MeshSat field kit V2, Option A(i) lid pack: sheet A1-2 sections: the module under the ceiling over the face, at the worst room

MeshSat field kit V2, Option A(i) lid pack: sheet A1-3 the arrangements that fit, and the owner decision

MeshSat field kit V2, Option A(i) lid pack: sheet A1-4 the hinge harness: route, travel, ties, disconnect; the QMX DC lead re-routed

MeshSat field kit V2, Option A(i) lid pack: sheet A1-5 mass and open-lid stability

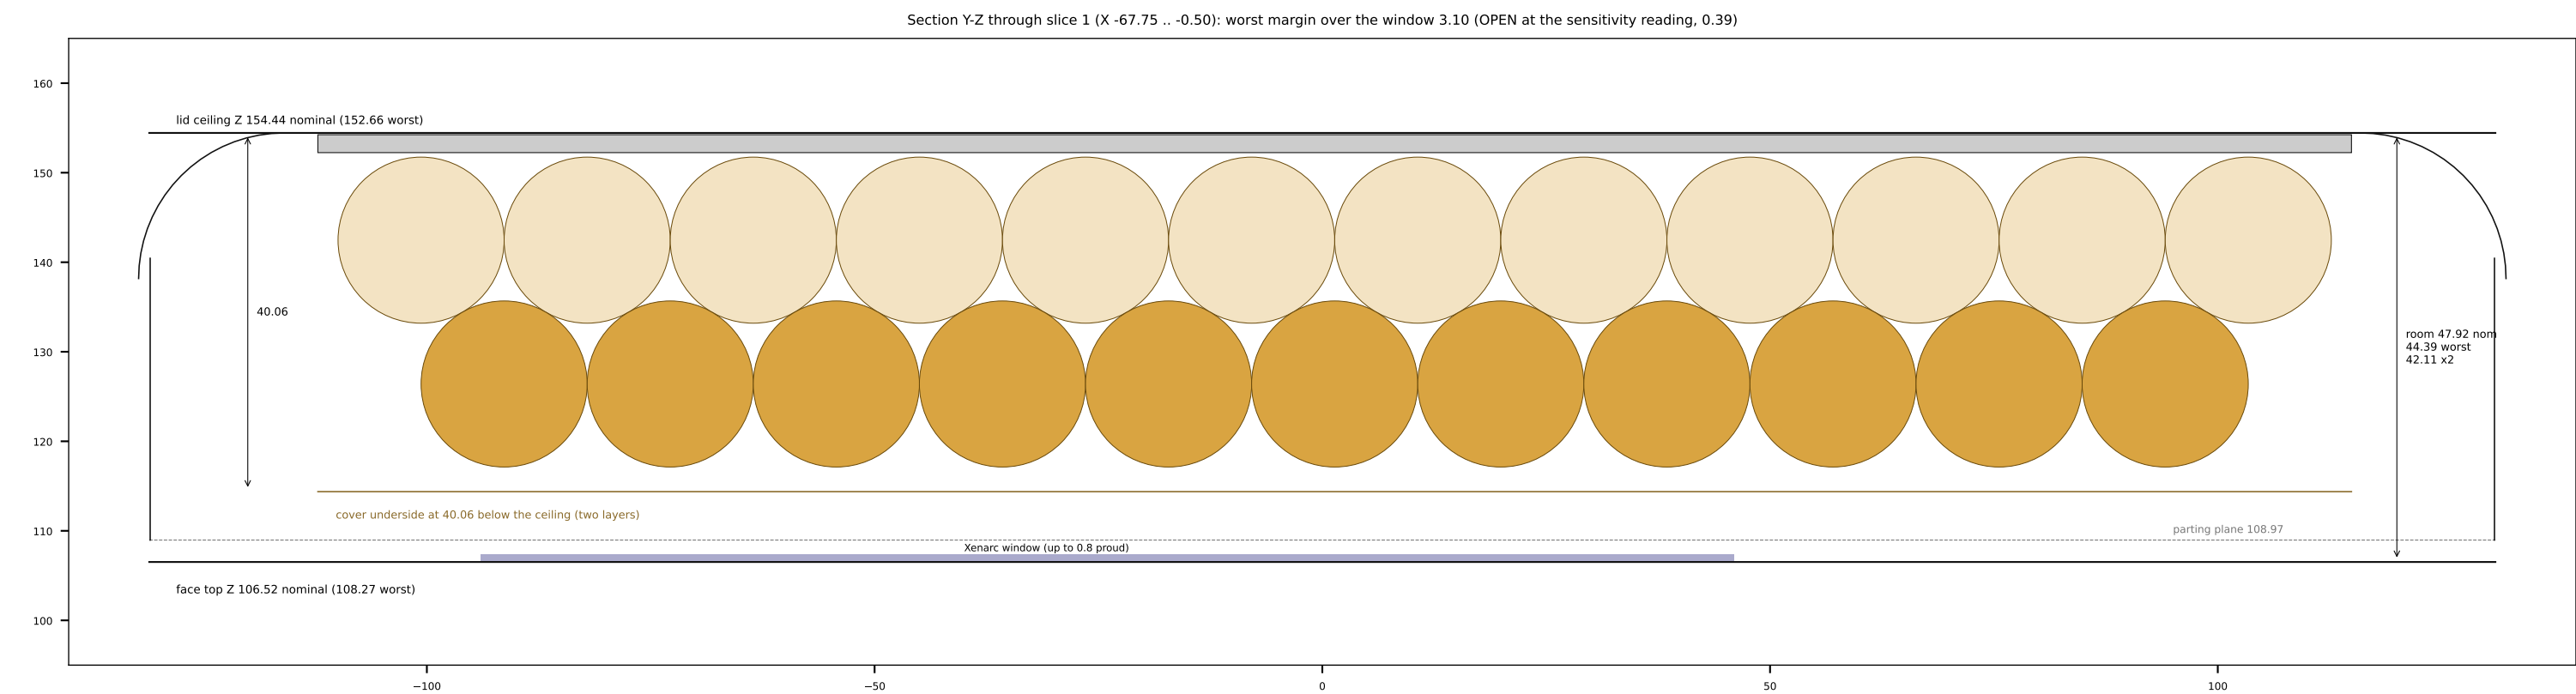
```
TIGTEST ROWS (worst, x2; min 1.0)
two layers over the Xenarc window 0.80: 3.10, 0.39 OPEN
two layers over the LED bar 1.50: 2.40, -0.31 OPEN
two layers over the e-paper lens: 3.85, 1.14 MET
one layer over the XFRAME screws: 15.96, 13.25 MET
layer 2 refused over XFRAME 1 and 3 (4.00): -0.10 worst
```

PLAN module to the QMX tray 10.45; inside the flat ceiling
1.00 in Y (the fillets begin at +/-115.93)
west edge 2.0 from the toggle guard caps (X -143.0)
west slice stops north of the headset jacks (TBD)

OPEN AT THE MOCK-UP: T9 (chalk on the module's cover and the face parts, lid closed), T8 (pull test of a bonded plate on Peli's polypropylene), T-A1-1 to T-A1-4 of the README.

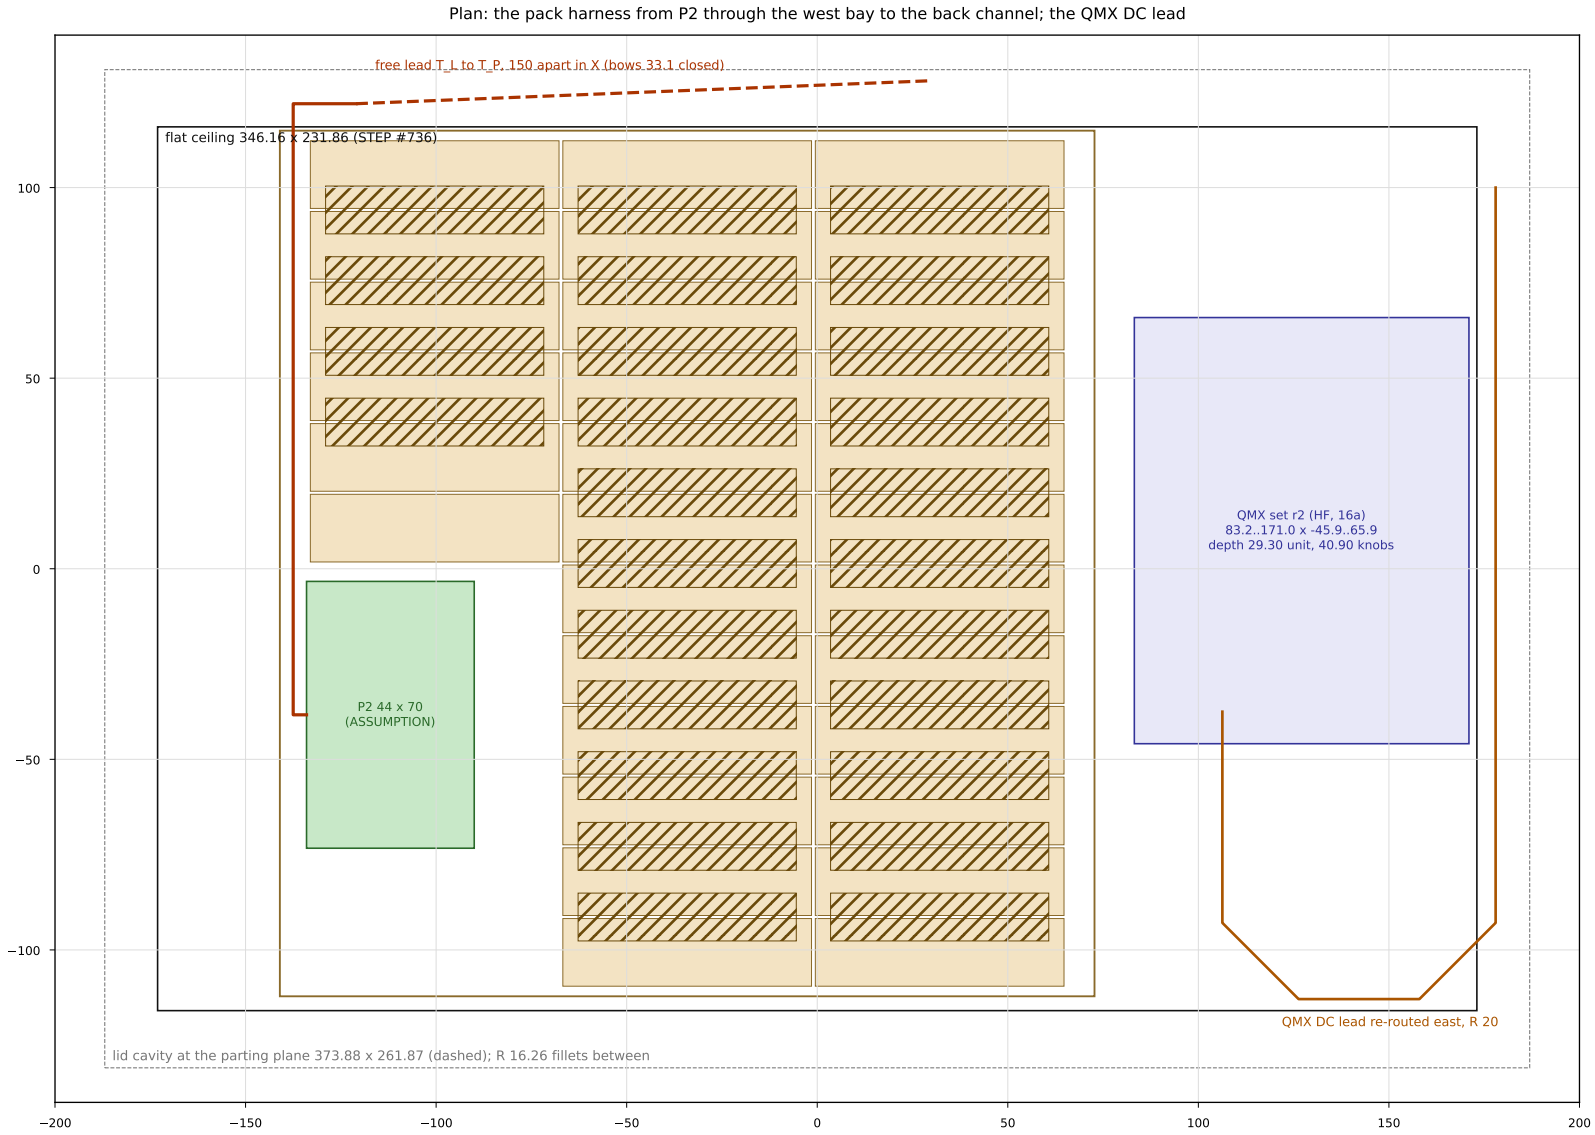
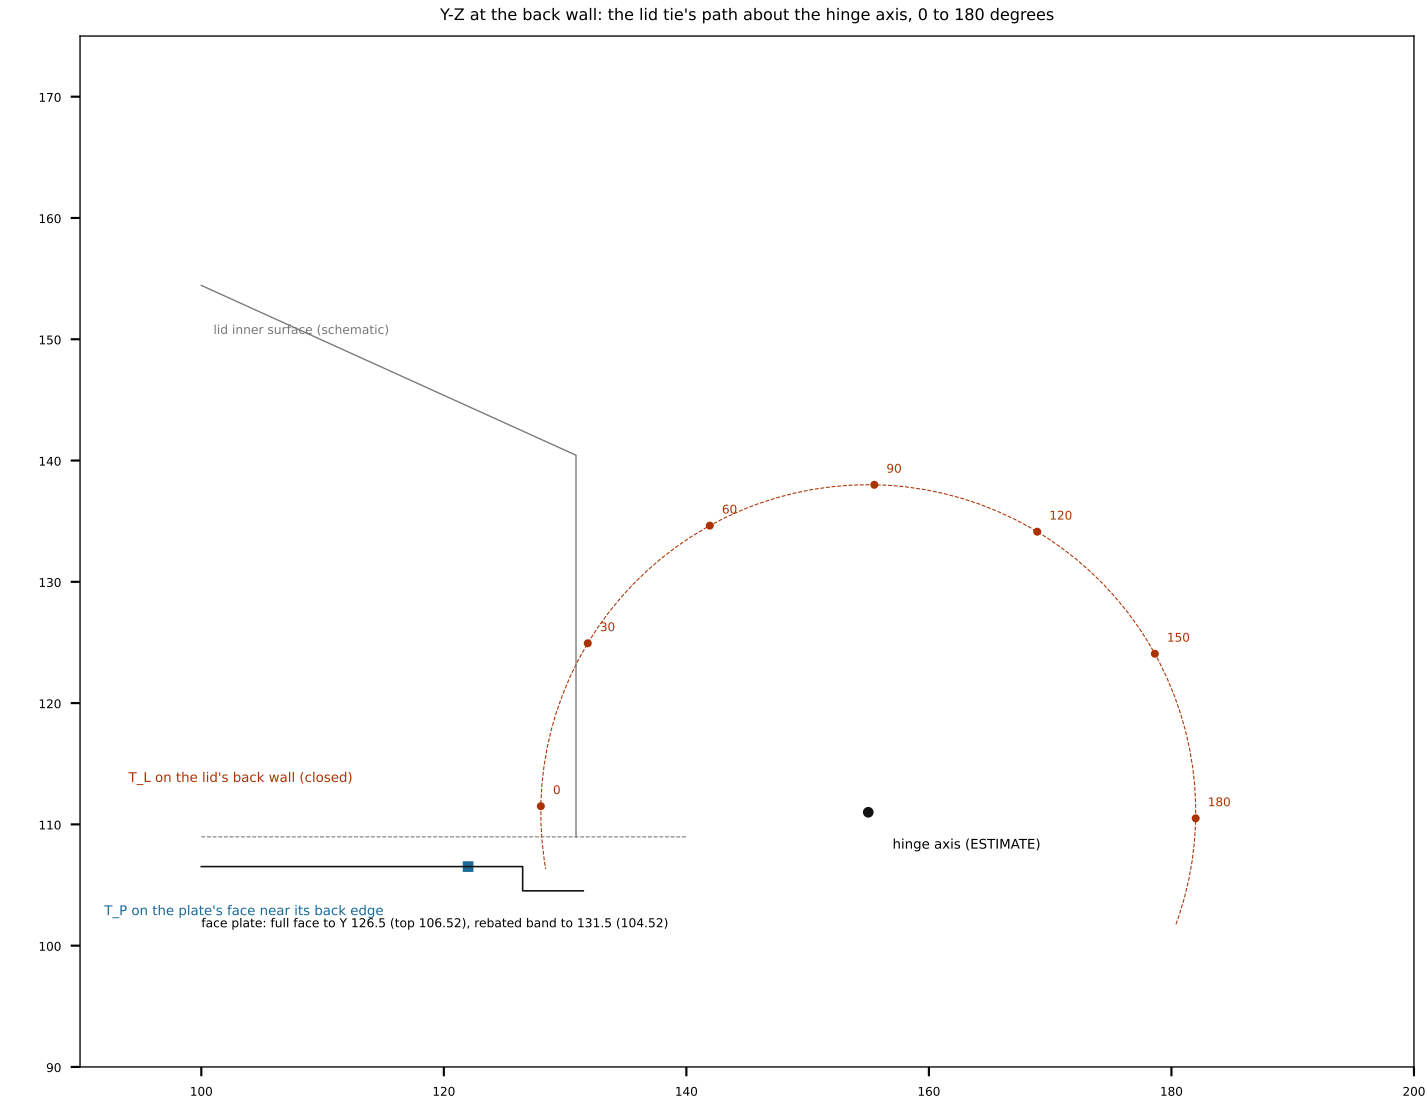
48 cells (4S12P) in the lid with BOTH the QMX HF set (16a) and the tablet bracket (16d): DOES NOT FIT. At the worst room the lid holds 35 places with both, 4S8P; the total 4S14P is under section 9c's 4S15P floor.

What fits 4S12P (each with every row of sheet A1-1 at or above its minimum at the worst):
1. HF kept, tablet bracket out of the lid: 56 places (4S14P); the tablet goes out of the case.
2. 8 inch tablet kept, HF (QMX) out of the lid: 58 places (4S14P); HF inside (16a) is lost: the base has no volume for the QMX set (section 8)
3. Both kept, lid pack 4S8P: not Option A(i); M1 not met on section 9's model

10 inch tablet: fits only with HF out: 47 places (4S11P). Both out: 77 places (4S19P).

Session's recommendation (engineering view only): option 1, which keeps a radio bearer and gives 8 spare places; the tablet works from outside the case on the kit's WiFi and USB-C outlet.

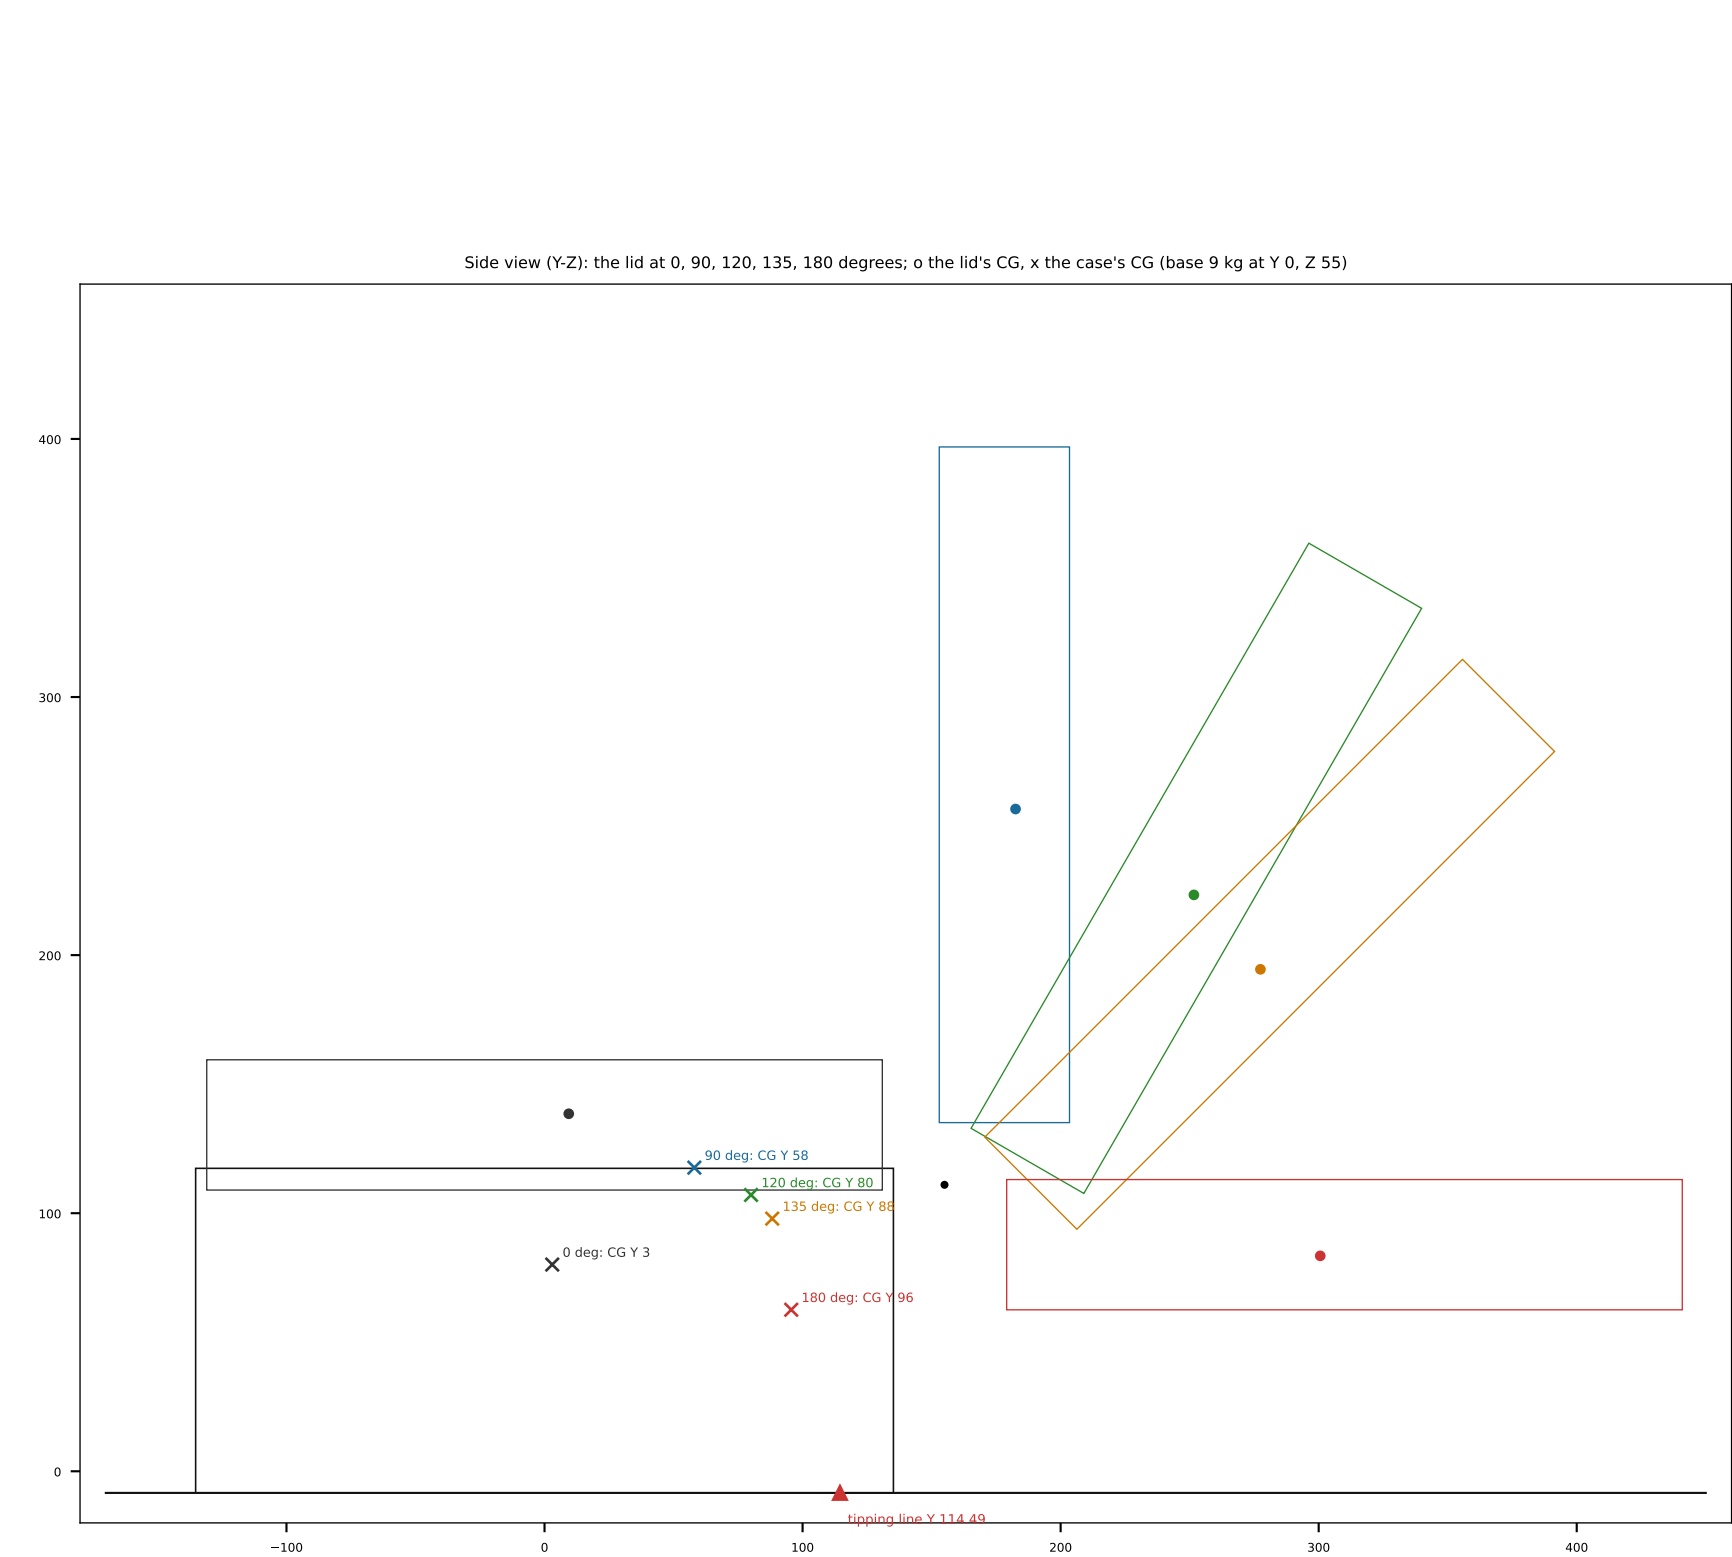
WORST OVER THE SWEEP (base 7..14 kg, CG Y -20..+20, Z 45..65, hinge axis Y 147..163): critical back slope, deg			
lid open	B	A	
90	14.9	17.1	
100	11.6	14.0	
110	8.4	11.1	
120	5.4	8.4	
135	1.3	4.9	
150	-2.2	2.2	(tips on level ground)
180	-5.0	1.7	(tips on level ground)

VERDICT: stands on level ground to 120 degrees of opening in every swept case; a light base tips from 135. FIX (SESSION, reversible): a lid stay stopping the lid at 100 degrees (webbing strap between two bonded anchors, lid back wall and plate back band; no hole; about EUR 10, ESTIMATE). With it the open case stands on a slope of about 10 degrees at the worst (lid_pack_a1.out section 4). The stop angle, the hinge axis and the case's CG are read on the mock-up (T-A1-3); Peli states no load for its hinges (T-A1-4).
